Agenda
Village of Arlington Heights
Design Commission
Community Room, 3rd Floor

Item: DC#17-090 - Ivy Hotel - 519 W. Algonquin Rd.

STAFF DESIGN COMMISSION REPORT

Project Name: Ivy Hotel
Project Address: 519 W. Algonquin Road
Prepared By: Steve Hautzinger

2 PROPOSED NORTH (FRONT) ELEVATION
SCALE : 3/32" = 1'-0" JUNE 26, 2017

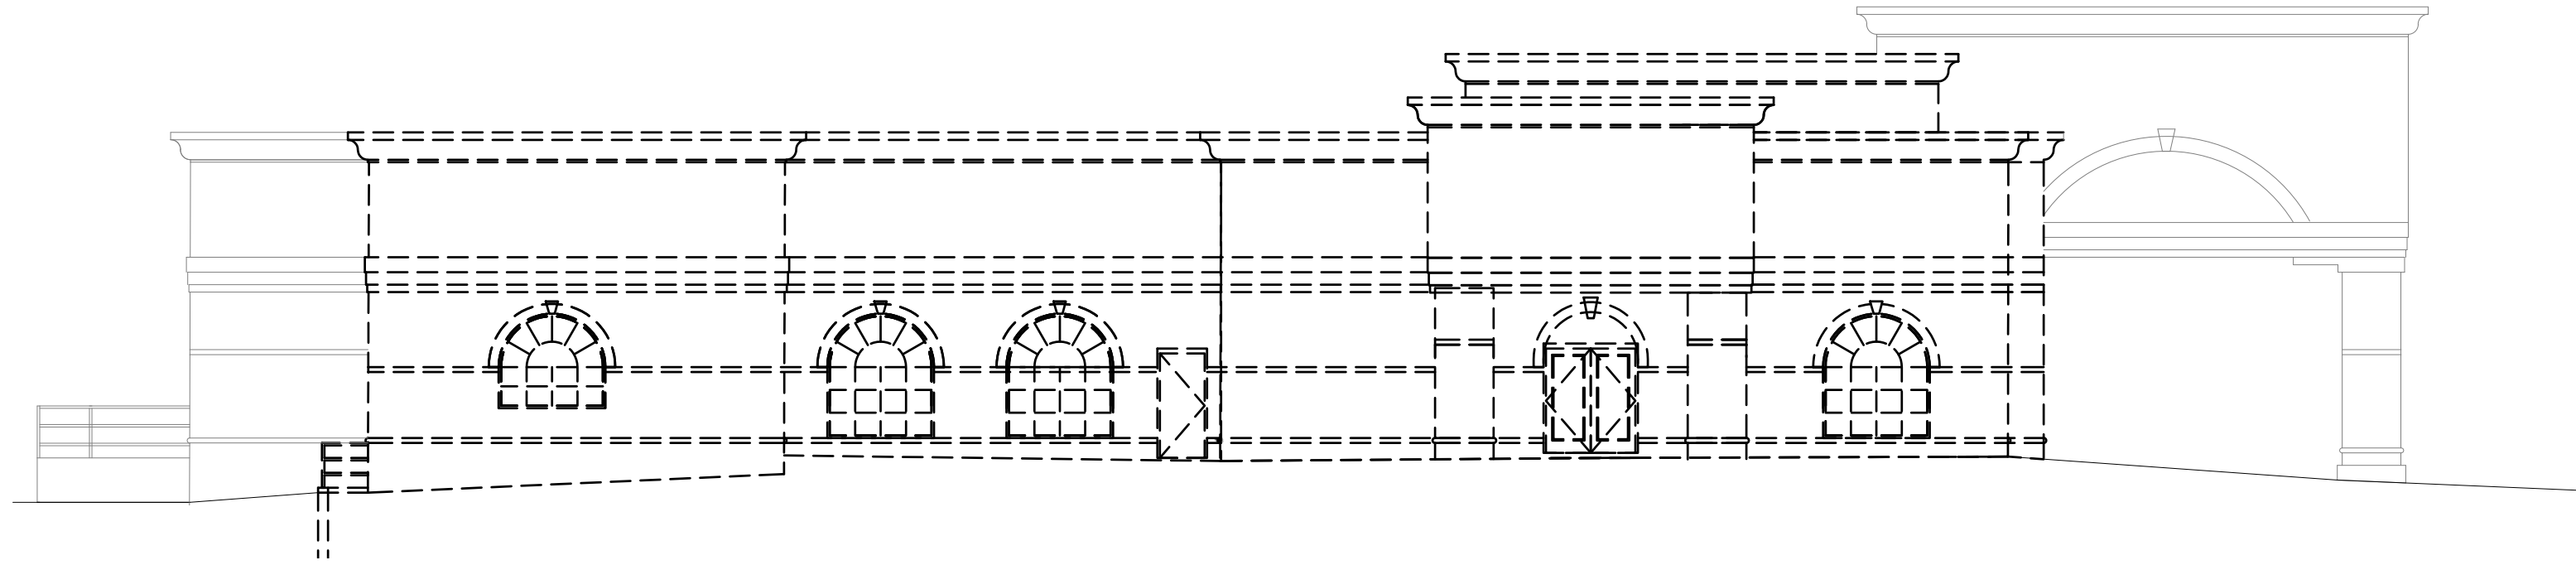
The original design included a very nice sloping porte-cochere structure with suspended undulating panels that created an attractive appearance from the street and an exciting arrival experience, but the new design only has a small and unremarkable entrance canopy that the Design Commission should evaluate.

1. Evaluate the design of the small entrance canopy versus the previously approved porte cochere
2. Add the curtainwall feature to the south façade to match the north façade.

2 PROPOSED SOUTH (REAR) ELEVATION

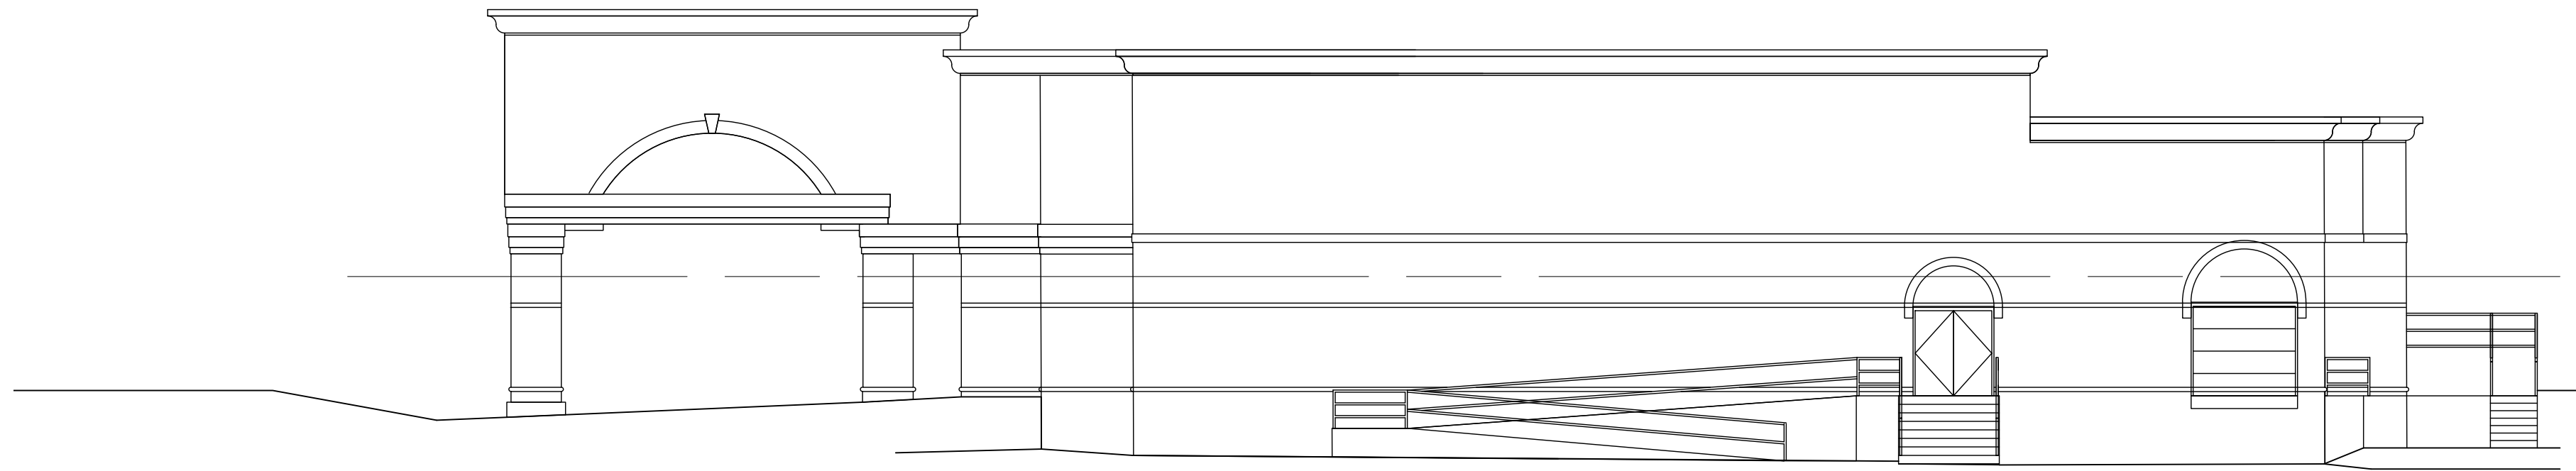
The original design had the nice curtainwall feature on both sides of the building, but the revised design only has the curtainwall on the north wall. The south wall has a dull appearance, and it will be visible from I-90. It is recommended that the curtainwall feature be added to the south facade.
